Flight Procedures Cover Page	Task Action: FLIGHT CHECK	Task Type: SID	Estimated Chart Date: 03/19/2026	APWS Task ID: 03BA7FF80A3245D8ABBC9D275A5471F2	APWS Project ID: E1B77178A13549D3A6BDFCE42772442D
Procedure: ALPIN FIVE - JACKSON WY KJAC		Enroute: NO	Specialist: Hirst, Charles		Agreement Number:
Airport ID: KJAC			Airport City: JACKSON		State: WY
Facility ID:	Facility Type:	Flight Inspection Remark Type: New FC Slot

PROCEDURE: ALPIN FIVE DEPARTURE		AIRPORT NAME: JACKSON HOLE		AIRPORT ID: KJAC	SPECIAL CONTROL NO: SG-10-294-25
FAC ID: ALPIN5		CITY: JACKSON		ST: WY	ORIG CHART DATE: 03/19/2026
DFL TYPE: PROC/B	THIRD PARTY: <input type="checkbox"/> YES	EST. TIME ON SITE: 0.5	REIMB. NUMBER:	PTS TASK ID: 03BA7FF80A3245D8ABBC9D275A5471F2

(ALPIN5.KICNE) FIG
ALPIN FIVE DEPARTURE

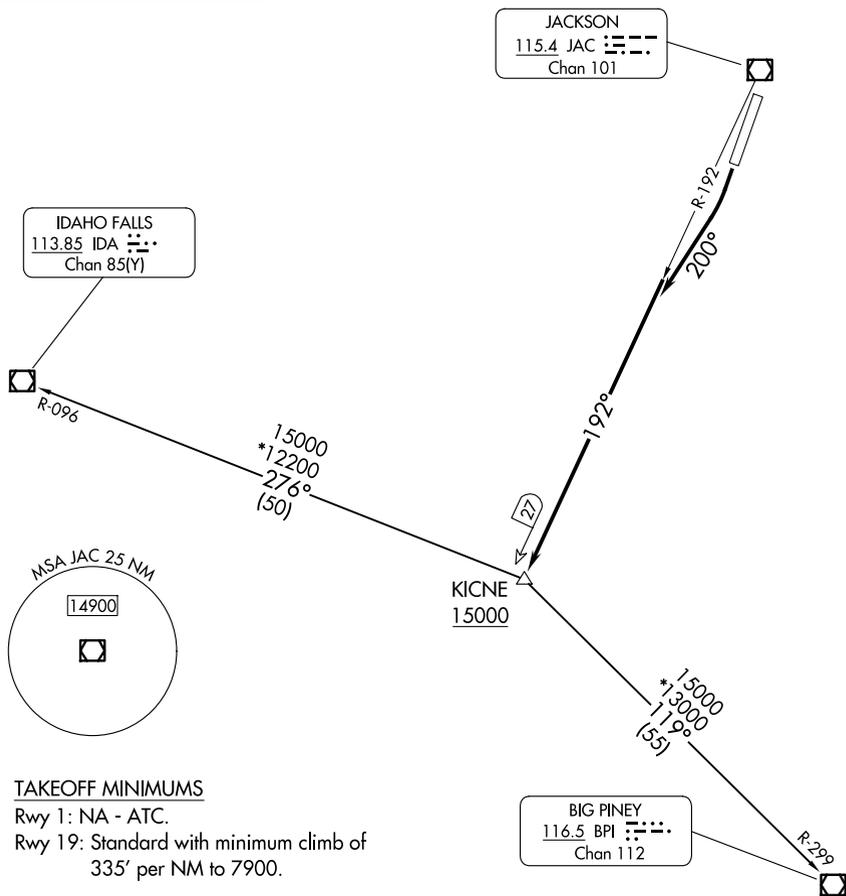
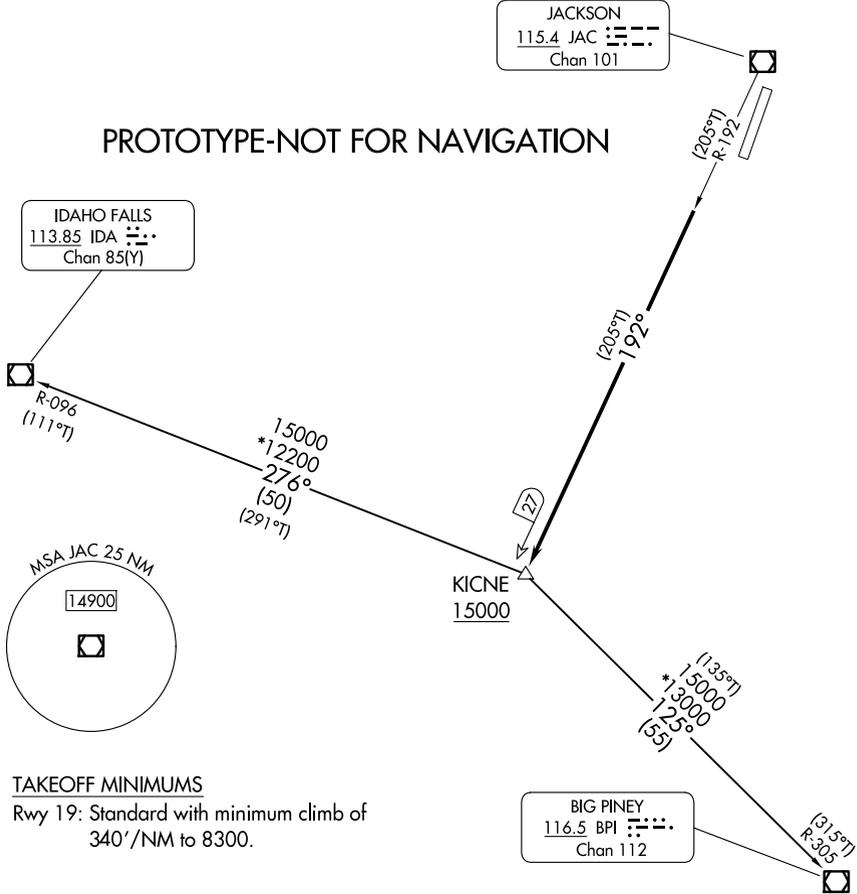
BPI VOR/DME MAGVAR UPDATED FROM 16E TO 10E IN JUNE 2023 BUT ALPIN SID WAS NEVER UPDATED WITH NEW NAVAID MAGVAR FOR THE BPI TRANSITION. UPDATING PROCEDURE WITH REVISED CG/CGTA AND BPI TRANSITION INSTRUCTIONS.

BIG PINEY TRANSITION (ALPIN5.BPI): From over KICNE INT on BPI R-305 to BPI VOR/DME.

Rwy 19: Standard with minimum climb of 340'/NM to 8300.

TAKEOFF RUNWAY 19: Climb on JAC VOR/DME R-192 to KICNE INT/JAC 27 DME, cross KICNE INT at or above 15000, then on transition. Maintain ATC assigned altitude. Expect filed altitude 10 minutes after departure.

JACKSON HOLE AIRPORT
KJAC
JACKSON, WY
ALPIN FIVE SID
BPI VOR/DME ENROUTE TRANSITION
1:550,000

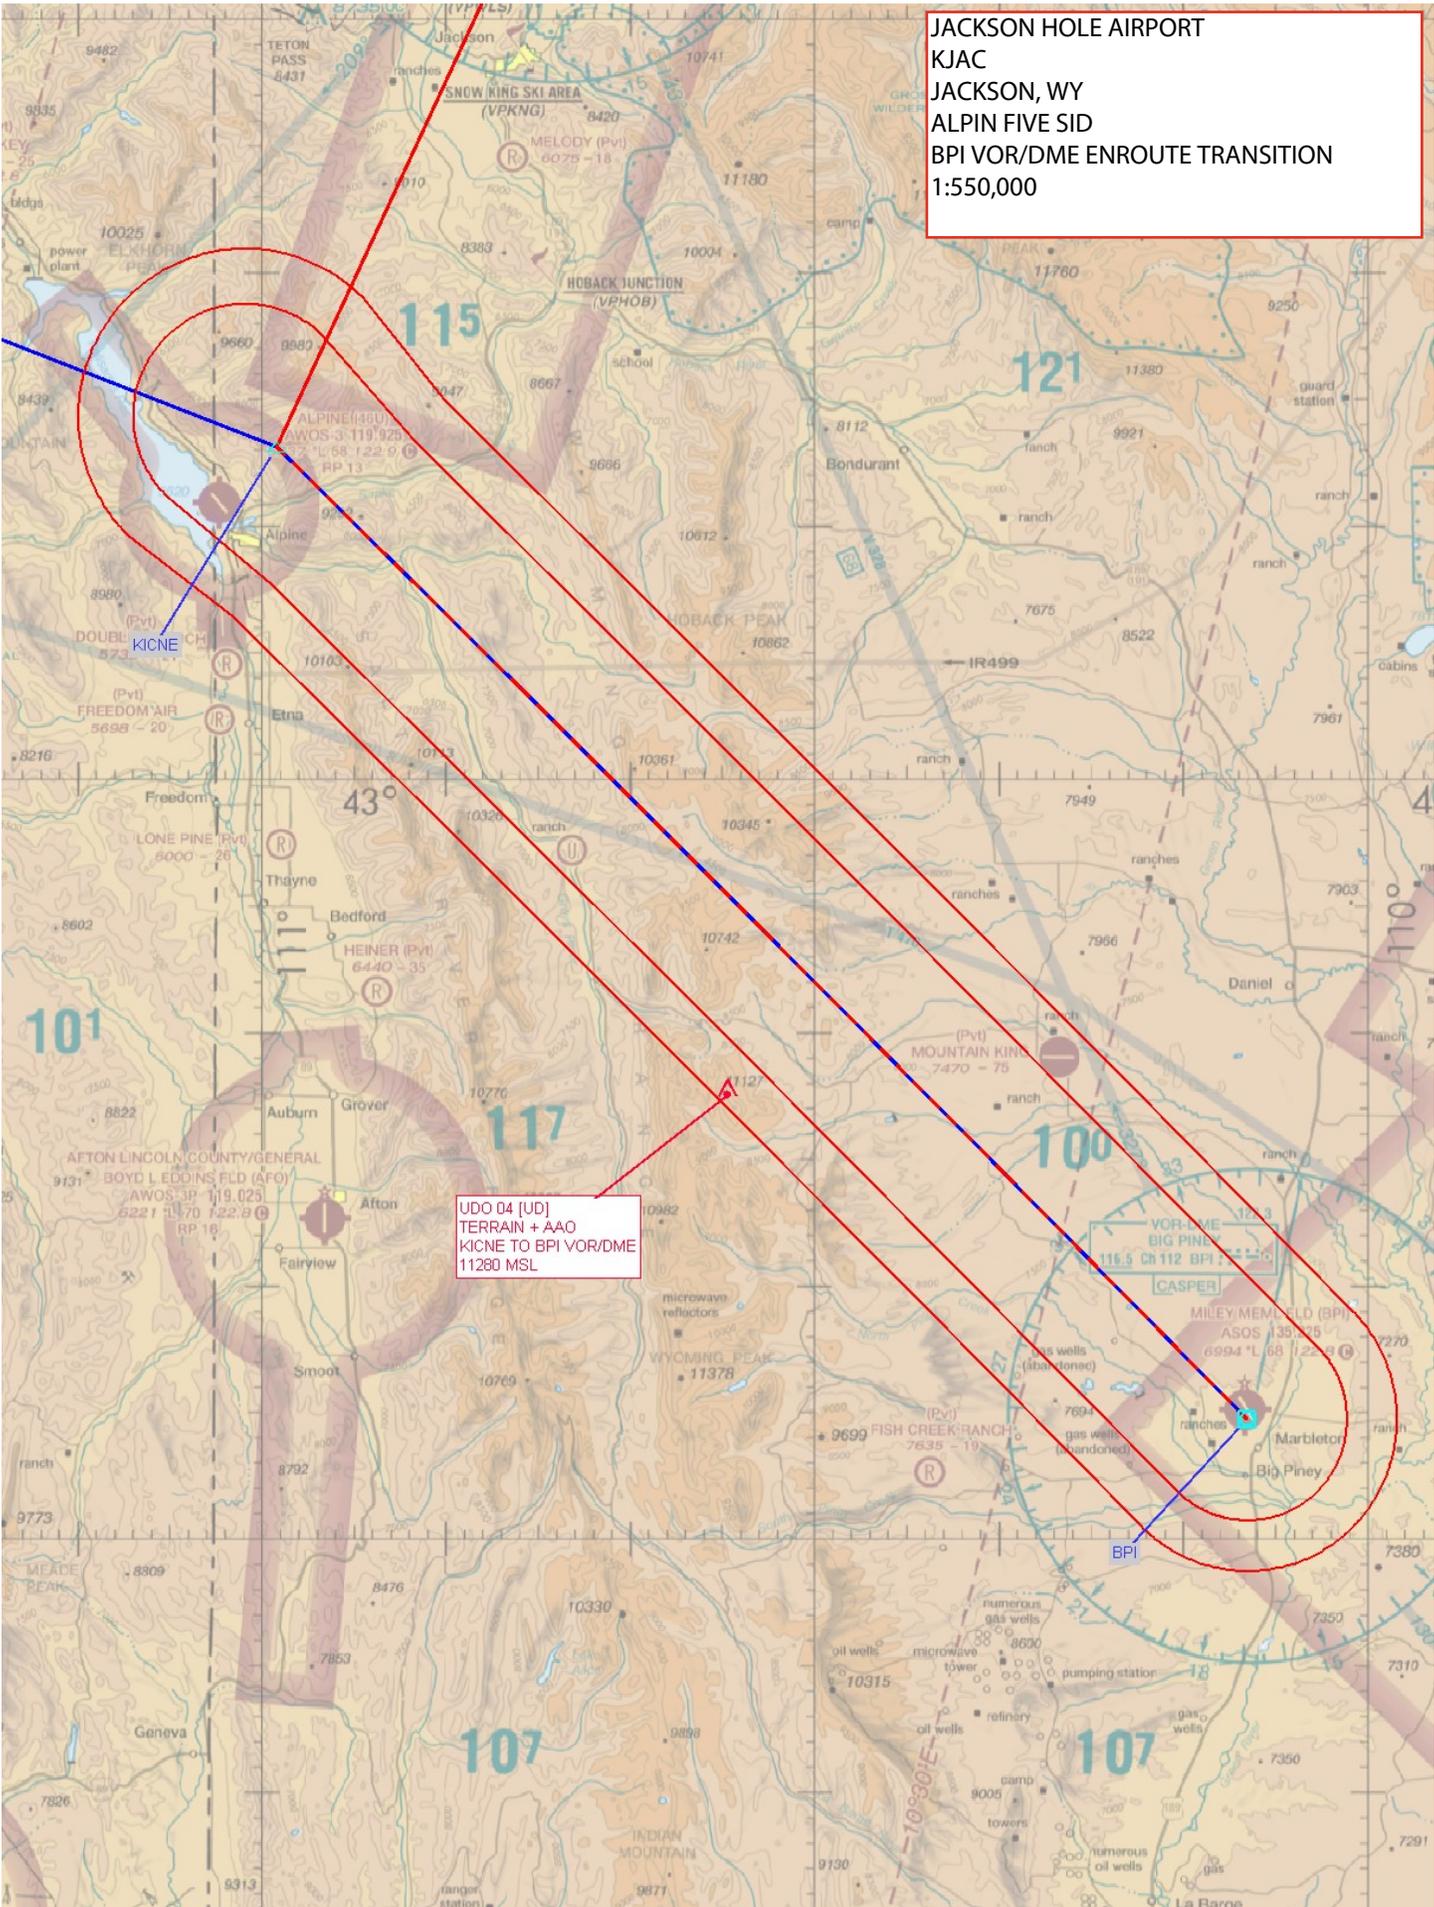
REVIEWER: jordan rolih			DATE: 11/25/2025				
COMMENTS: Table top. Requested ESV for Big Piney (BPI) is not required due to facility type change from "H" class to "VH" class. Previous ESV is no longer considered an ESV since it is now within the service volume. The requested ESV was for the KICNE fix.			CHECK ONE:				
			<input type="checkbox"/> FLT CK REQ <input checked="" type="checkbox"/> NFCR <input type="checkbox"/> REJECT				
			CPV COMPLETE?			YES	NO

FLIGHT INSPECTOR REMARKS:
 Table top. Requested ESV for Big Piney (BPI) is not required due to facility type change from "H" class to "VH" class. Previous ESV is no longer considered an ESV since it is now within the service volume. The requested ESV was for the KICNE fix. No electronic data required.
